Bayside Planning Panel

Item No	6.4
Application Type	Development Application – Multi Housing Dwellings
Application Number	DA-2017/1162
Lodgement Date	20 September 2017
Property	190 King Street, Mascot Lot 5 Sec 3 in DP 1873
Owner	Kabouchi Holdings Pty Ltd
Applicant	Urban Link Pty Ltd
Proposal	Proposed alterations and additions of an existing heritage item single storey residential dwelling facing King Street and construction of new 2 x 2 storey 4 bedroom terraces and attached garages with access from King Lane, including removal of trees
No. of Submissions	First Notification (18/10-1/11/2017) - four (4) objections Second Notification (25/1-13/2/2018) – four (4) objections
Cost of Development	\$1,372,154.00
Report by	Olivia Yana, Acting Development Assessment Planner

Supplementary Assessment Report

Applicant's response to outstanding matters deferred by the panel

Figure 2: Amended Roof Plan Rev E

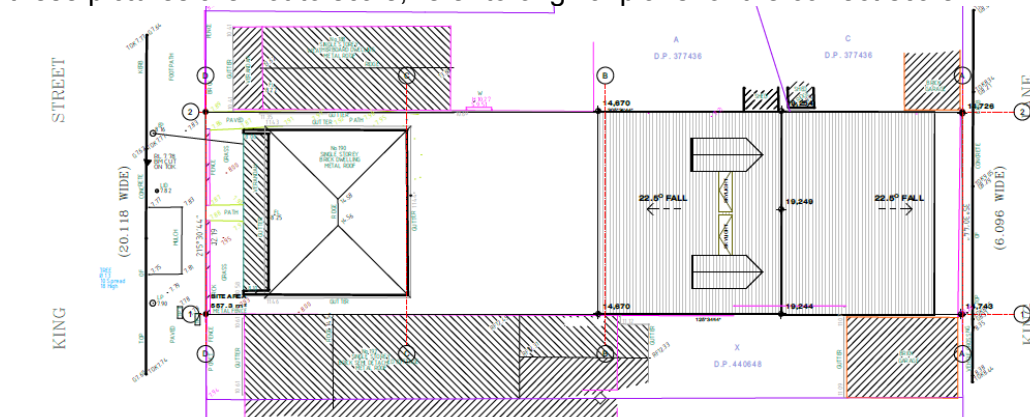
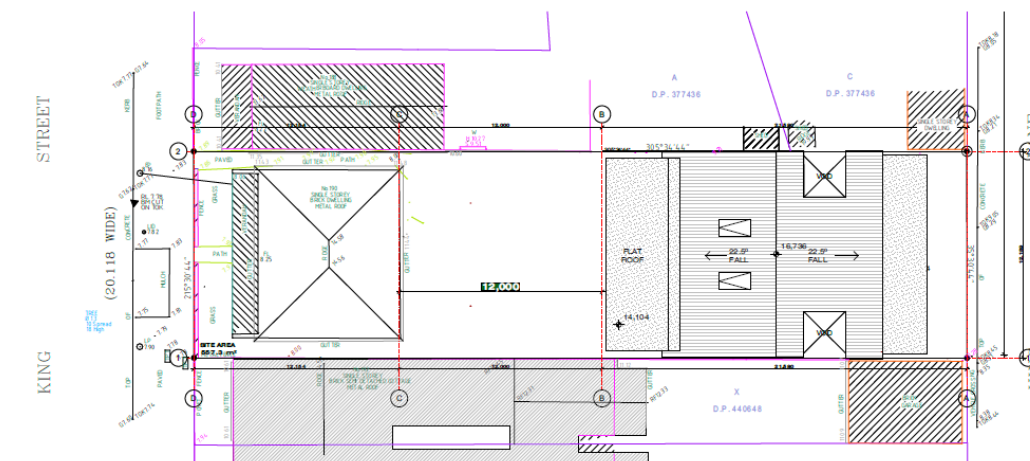
Key Controls	Required	Plans presented at BPP Meeting 14 December 2017	Plans to be presented at BPP Meeting 13 March 2018
Site Area	-	557.3m ²	557.3m ²
BBLEP 2013			
Zone	B2 – Local Centre	Multi dwelling	Unchanged
FSR	2:1	0.9:1	0.71:1
GFA	1114.6m ²	506.7m ²	397.3m ²
Height	14 metres	10.9 metres (RL19.24 AHD)	8.39 metres (RL16.73m AHD) – deletion of attic level lowered by 2.51 metres

Amendment to the development proposes the reduction in height with the deletion of the attic level, incorporating flat roof forms to part of the building facing the rear of the existing heritage item and the garage, and lowering the height of roof by 2.51 metres to RL16.73m AHD and pitch to 22.5°. The following sightlines diagram has been provided to demonstrate the impact from the proposed roof. No photomontage to establish the impact from the proposed development to the existing view and sightlines has been provided by the applicant. Nevertheless, the following diagram shows that the changes proposed will lessen the bulk and scale impact of the proposed development to the heritage item, the streetscape and the adjoining properties, which are predominantly single storey residential development.

Figure 4. Amended Eastern Elevation Rev E

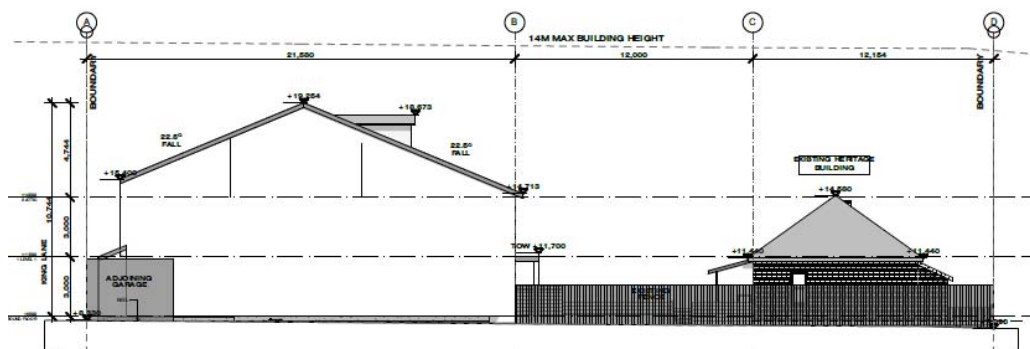
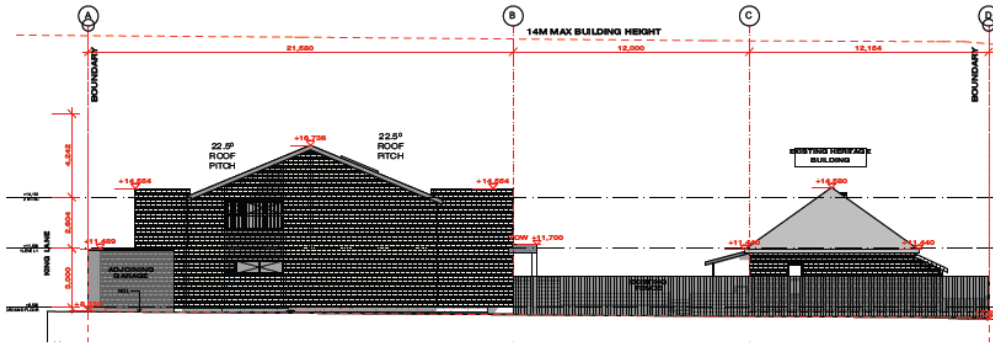
Additional side gardens with dimensions of 3 metres x 3 metres are proposed in the amended plans, which provide the articulation and reduce the bulk from the side walls. The proposed articulation complies with control C10 of Part 4B.2.10 Setbacks, Building Frontage and Separation of the DCP for multi housing dwellings for buildings greater than 7 metres for the length of 3 metres.

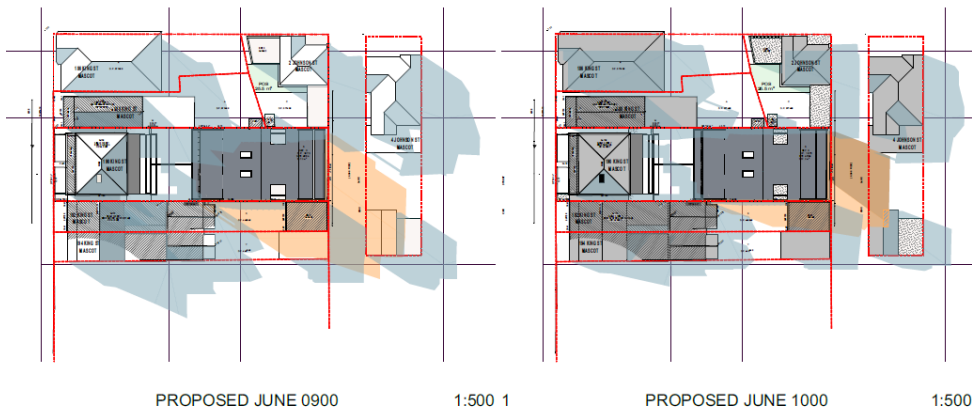
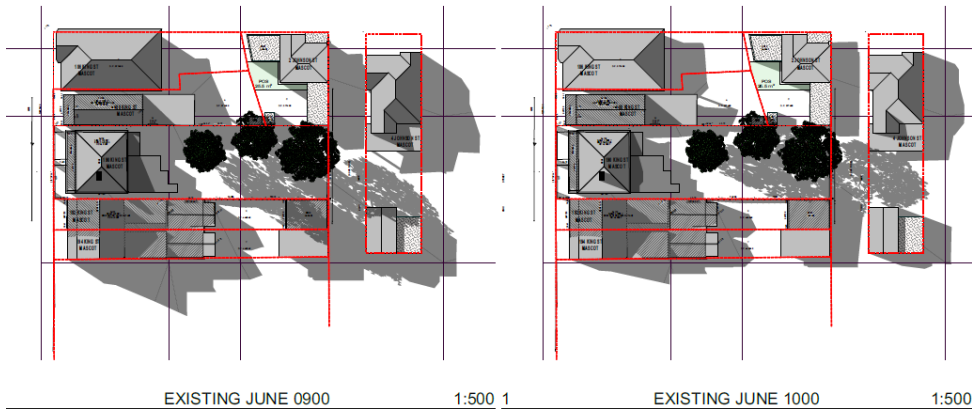
The applicant has provided additional side gardens with dimensions of 3 metres x 3 metres to the eastern and western side boundaries. Even though, the landscaped area has been increased by 12m², the proposed development is still deficient of soft landscaping required. Replacing hard landscaping area with permeable materials could increase the soft landscaping by providing porous pavers to the front setback of the main dwelling facing King Street, the walking paths within the side setbacks, and the decking within the gardens between the rear terrace and the garages. This is recommended as part of the condition of consent to improve soft landscaping on site, given that the proposed drainage infiltration trenches are proposed within the landscaped area of the rear terraces that should be excluded from the deep soil zone.
